HISTORIC AND DESIGN REVIEW COMMISSION

March 03, 2021

HDRC CASE NO: 2021-053
ADDRESS: 311 MUNCEY
LEGAL DESCRIPTION: NCB 1657 BLK E LOT N 51 FT OF 15&16
ZONING: R-5, H
CITY COUNCIL DIST.: 2
DISTRICT: Dignowity Hill Historic District
APPLICANT: Anthony Chen/Aeonium Investments, LLC
OWNER: Anthony Chen/ROCHA CYNTHIA A & LARRALDE ALEJANDRO G
TYPE OF WORK: Construction of a rear addition, exterior modifications, fenestration modifications
APPLICATION RECEIVED: January 26, 2021
60-DAY REVIEW: Not applicable due to City Council Emergency Orders
CASE MANAGER: Edward Hall
REQUEST:

SHEET NAME:
FLOOR PLANS
(EXISTING / PROPOSAL)

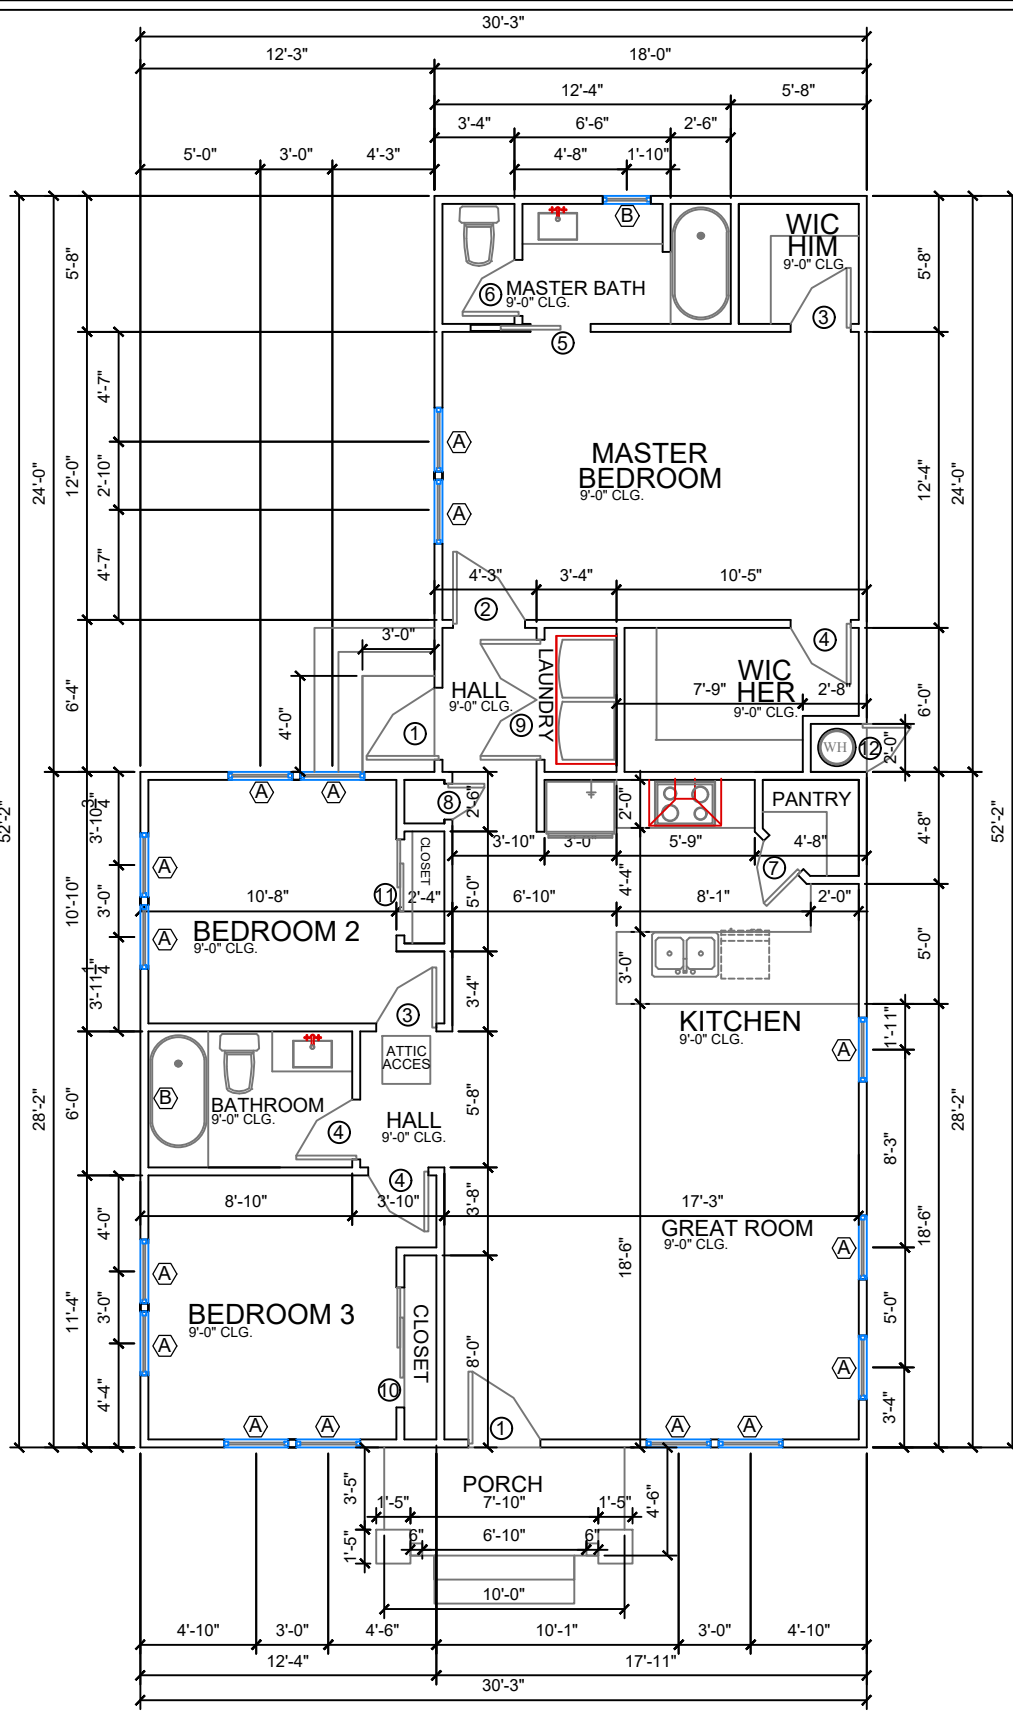
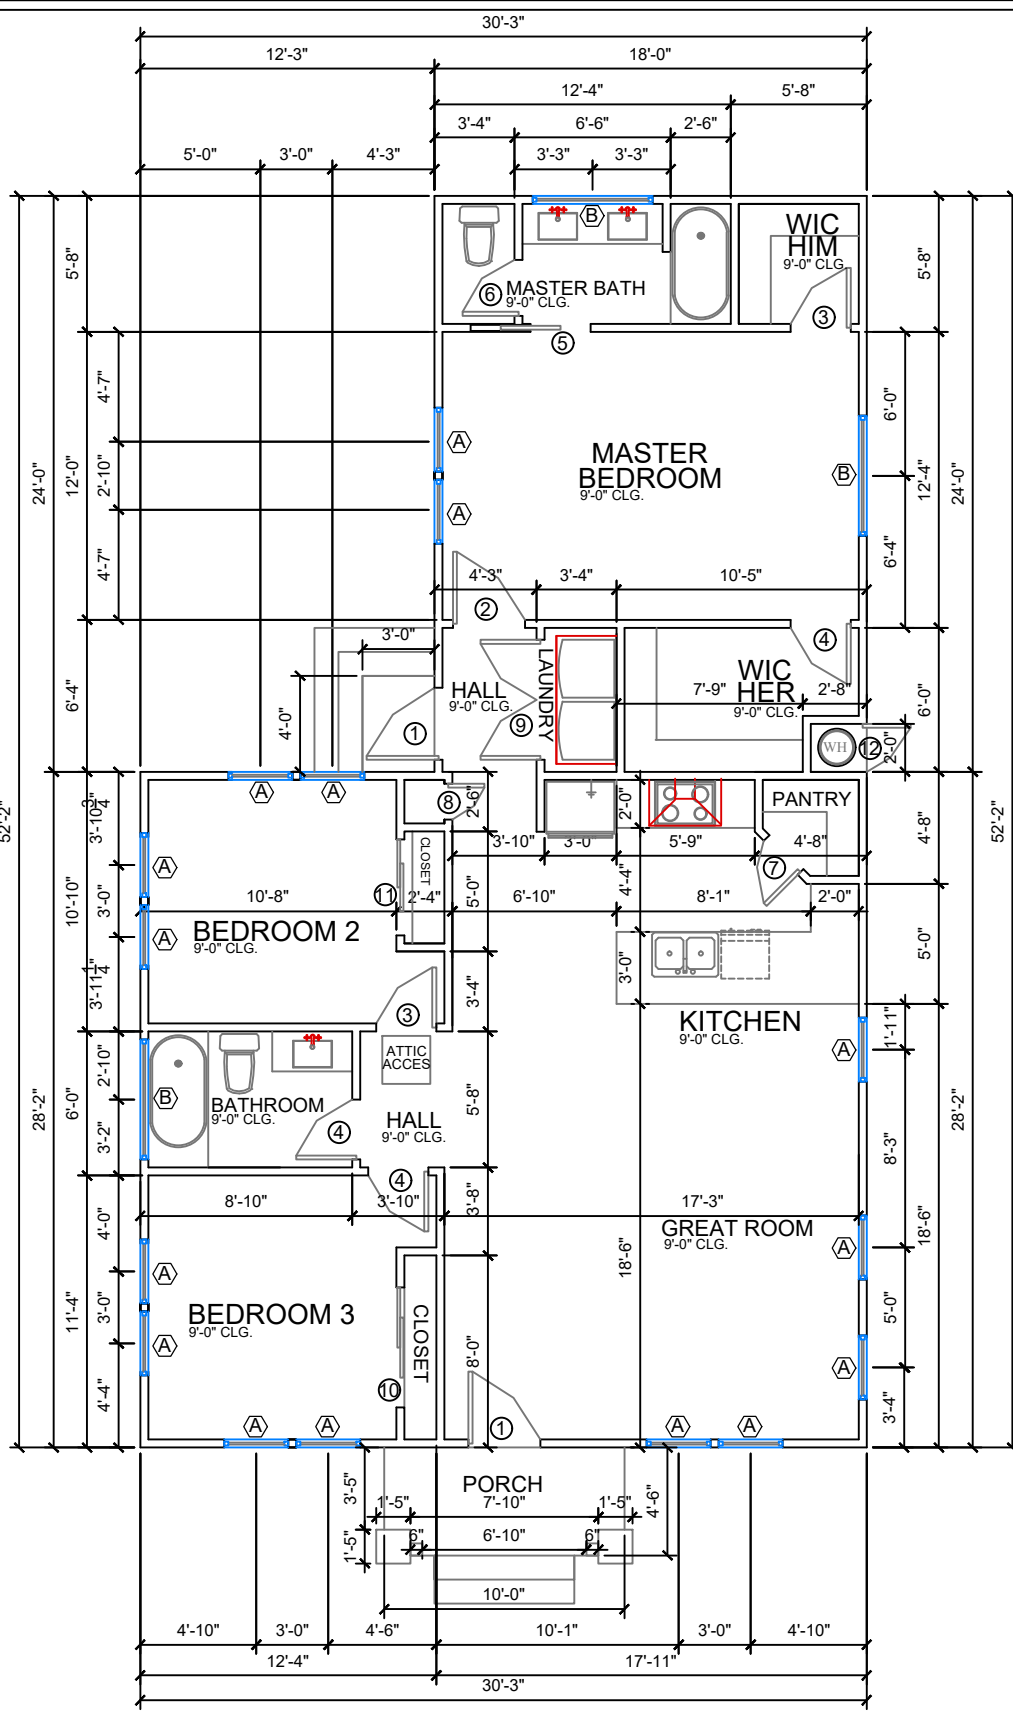
- b. FENESTRATION MODIFICATIONS (North elevation) – The applicant has proposed to modify the fenestration on the north elevation by increasing the size of one original window opening, and by removing two existing window openings at a rear, enclosed porch. Additionally, the applicant has submitted an alternative proposal that includes the installation of a new window profile beneath the side gable. The Guideline for Exterior Maintenance and Alterations 6.A.i. notes that historic window openings should be preserved. Staff does not find the removal of original window openings nor the introduction of new openings to be appropriate or consistent with the Guidelines.

- c. FENESTRATION MODIFICATIONS (South elevation) – The applicant has proposed to modify the fenestration on the south elevation by removing one existing window opening. The Guideline for Exterior Maintenance and Alterations 6.A.i. notes that historic window openings should be preserved. Staff does not find the removal of original window openings to be appropriate or consistent with the Guidelines.

- g. REAR ADDITION (Fenestration and window materials) – The applicant has submitted two options for fenestration for the rear addition. Both options propose fenestration profiles that are inconsistent with those found historically within the district through the incorporation of contemporary window sizes and blank walls that are void of fenestration. Staff finds that window openings that match those of the primary historic structure in profile and size should be incorporated into the design. Staff finds that at least two window openings should be added to the right elevation. Regarding window materials, the applicant has submitted a number of window materials for the proposed addition. Staff finds the Jeld-Wen product to be most consistent with staff's standard specifications for windows in additions.

1. Staff does not recommend approval of item #2, fenestration modifications to the north façade, as noted in finding b. Staff recommends that the historic façade be maintained as it exists.

2. Staff does not recommend approval of item #3, fenestration modifications to the south façade, as noted in finding c. Staff recommends that the historic façade be maintained as it exists.

SHEET NAME: FRONT & RIGHT ELEVATIONS	PROJECT NO. DATE: JANUARY 2021	CONTRACTOR:
	103

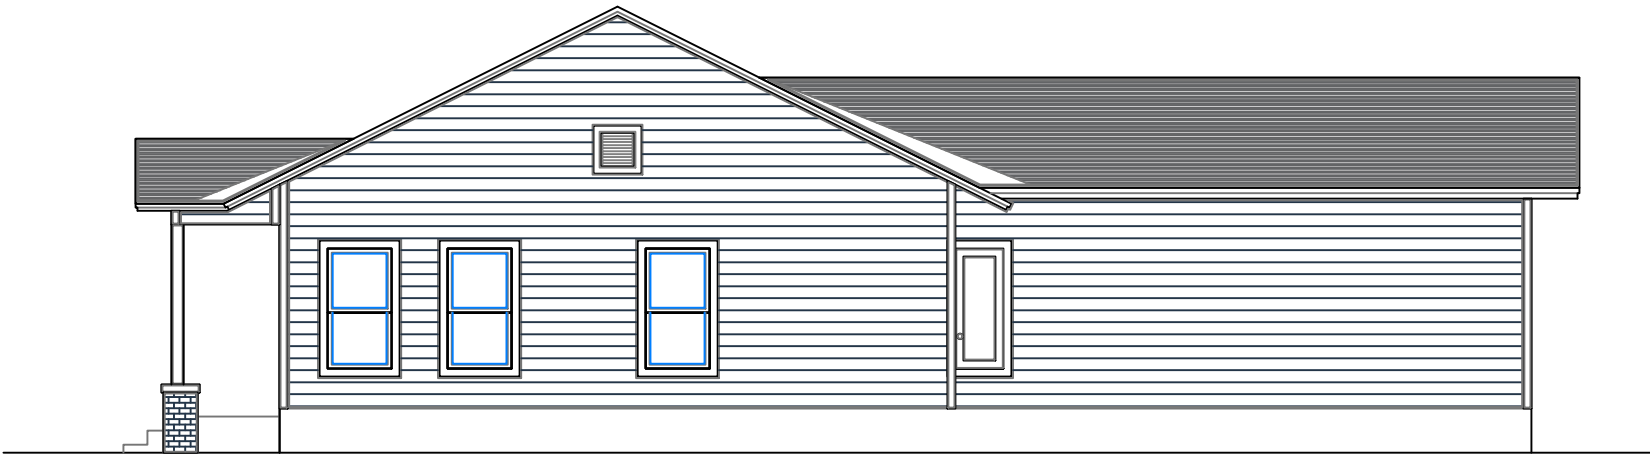
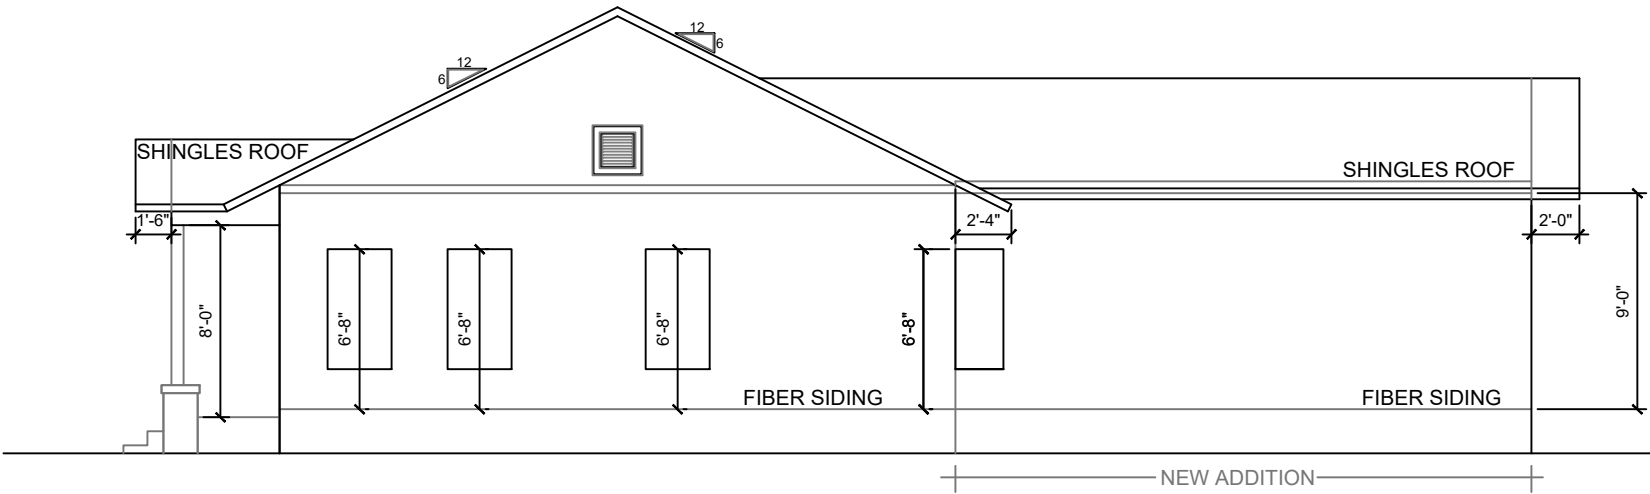
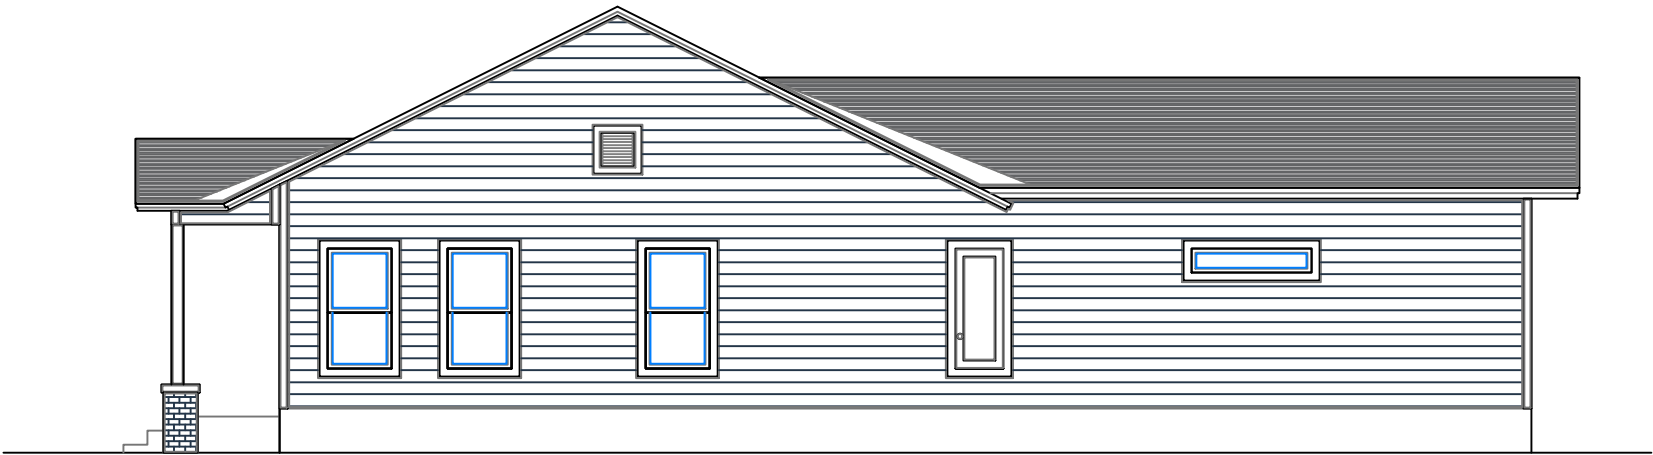
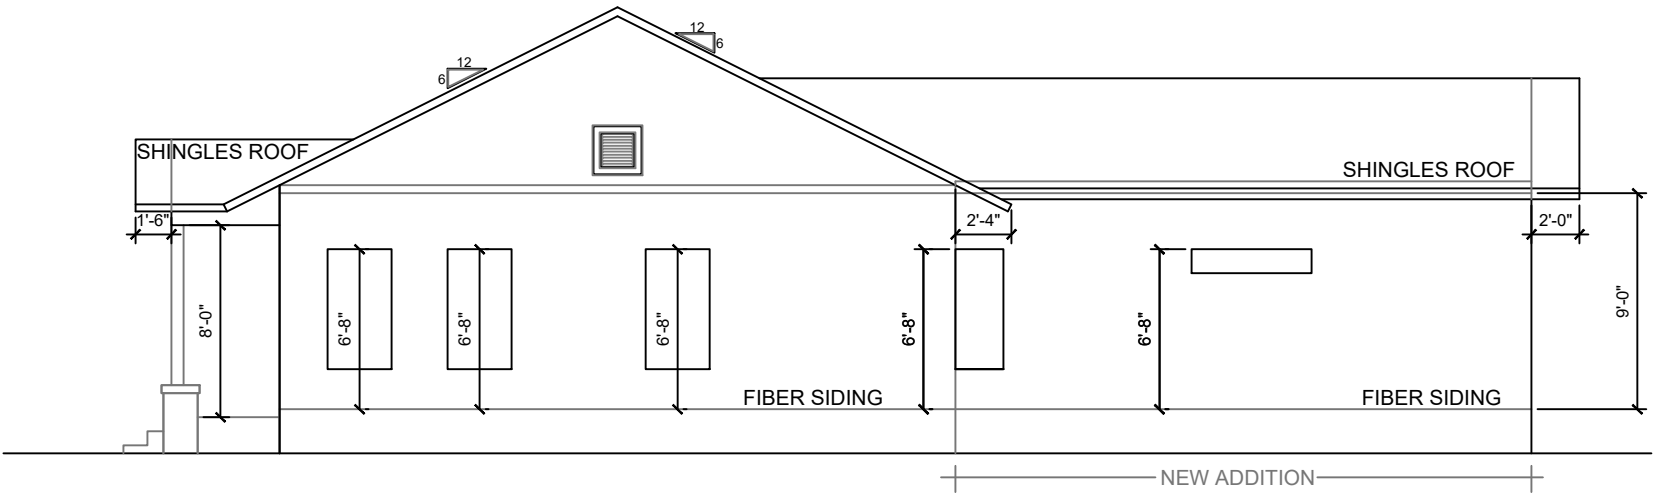
- e. REAR ADDITION – The Guidelines for Additions note that additions should be sited to the side or rear of the historic structure, should be designed in keeping with the historic context of the block, should feature a similar roof form and should feature a transition between the historic structure and new addition. Additionally, the Guidelines note that additions should not feature a footprint so large as to double the historic structure's footprint. Generally, the proposed addition is consistent with the Guidelines; however, staff finds that the applicant should ensure a visual break is present on the right (north) elevation to separate the addition from the new construction.

compliment the character of the original structure. Architectural details that are more ornate or elaborate than those found on the original structure should not be used to avoid drawing undue attention to the addition. As noted in finding h, staff finds that window openings that match those of the primary historic structure in profile and size should be incorporated into the design. Staff finds that at least two window openings should be added to the right elevation.

- i. That the applicant should ensure a visual break is present on the right (north) elevation to separate the addition from the new construction.
 - ii. That a standing seam metal roof is installed to match that of the primary historic structure.

- iii. That window openings that match those of the primary historic structure in profile and size be incorporated into the design. Staff recommends that at least two window openings should be added to the right elevation.
